### 8.1 DA0246/2021 Dual Occupancy at 90A Louee Street, Rylstone (Lot 3 DP1239243)

REPORT BY THE TOWN PLANNER  
TO 04 AUGUST 2021 ORDINARY MEETING  
GOV400088, DA0246/2021

Figure 3: Extract from proposed site plan

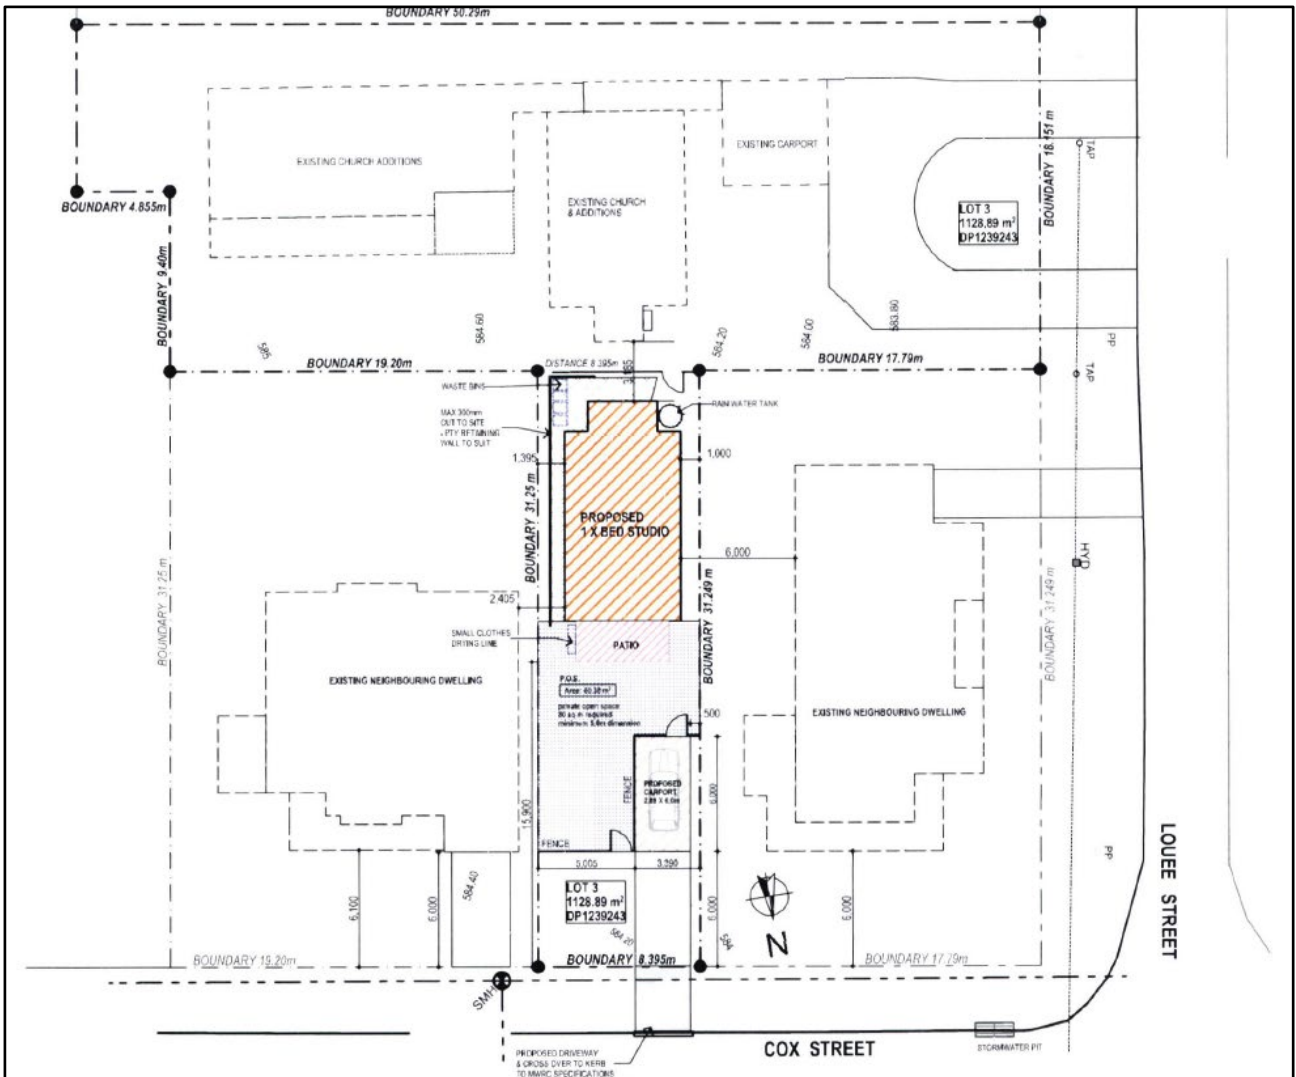
The application is recommended for refusal. The proposed development is considered to be inconsistent with the heritage controls under the MWLEP 2012 as the proposed new dwelling and car port will block views to the church building from Cox Street.

The principle heritage impact of the development will be through the loss of views to the Church from Cox Street as a result of the construction of the dwelling and car port within the viewing corridor.

- the proposed new dwelling will of course block the view which the corridor was designed to provide and consequently will diminish its heritage significance and its contributions to the significance of the conservation area.
- the argument in the SOHI that the studio will be an interpretation of the church is not accepted – interpretation means material introduced to a heritage site to assist in understanding its significance. The building will do the opposite. As the available views have been diminished, arguably too much so, the view to the original front elevation and entrance should be retained.

It should also be noted that a new carport and 1.8m fence will be located in front of the proposed dwelling resulting in the loss of any oblique views to the Church from Cox Street around the proposed dwelling.
